STAFF REPORT SAN CLEMENTE PLANNING COMMISSION

SUBJECT: Cultural Heritage Permit 15-040, Woodnutt Duplex, a public hearing to consider a request for an addition to a duplex at 318 Avenida Del Mar that abuts a historic property at 319 Avenida Cabrillo. The property is located in the Residential Medium zoning district and Architectural and Coastal Overlays (RM-A-CZ).

SUBJECT: **Cultural Heritage Permit 15-040, Woodnutt Duplex**, a request for an addition to a duplex at 318 Avenida Del Mar within the Residential Medium zoning district and Architectural and Coastal Overlays (RM-A-CZ).

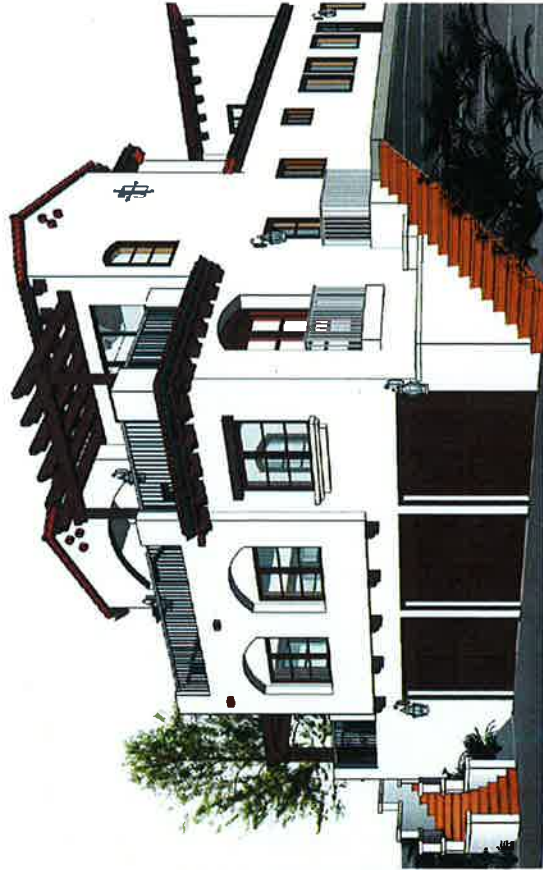
Architectural Detail	Summary of Detail	Recommendations for Improvement	Example(s) of Suggested Detail
Concrete S-tile	Concrete s-tile with random mortar packing is proposed on non-street facing roof planes	A traditional barrel tile roof with random mortar packing should be provided on all roof planes.	No image available.
Segmented arches - Front and east elevation	The segmented arches have a non-traditional corbel detail at the corners.	The segmented arches should not have corbels at the corners.	No image available.
Fascia board - All elevations	The plans show fascia boards.	Fascia boards are not traditional features and should be removed.	No image available.

Architectural Detail	Summary of Detail	Recommendations for Improvement	Example(s) of Suggested Detail
Wood lintel and potshelf - Front elevation	A wood lintel and potshelf are proposed around window.	Wood lintel and pot shelf are not traditional features and should be removed.	No image available.
Window recess design – Front elevation	Windows on the first floor are recessed within an arch.	Arched recess should be eliminated and recessed windows should be vertically oriented.	No image available.
Window – Courtyard south elevation	Vertical window on second floor.	The window is too large for the wall space and should be reduced in size.	No image available.
Wall opening – North elevation	The wall opening on the north elevation does not have any architectural detail.	A corbel detail or other detail should be added to the upper corners of the wall opening.	No image available.
Wood trellis	Wood trellis ends	Wood trellis should have corbel ends. Detail needed for review.	No image available.

Architectural Detail	Summary of Detail	Recommendations for Improvement	Example(s) of Suggested Detail
Windows and Doors	Fiberglass windows/doors are proposed.	A sample of the fiberglass windows/doors is needed for staff evaluation. Windows and doors should have lites and recessed a minimum of 12" to 18" as suggested in the Henry Lenny Design Guidelines.	
Lighting	Lighting type and locations are not depicted on elevations.	Traditional wrought-iron lighting should be utilized and shown on the elevations.
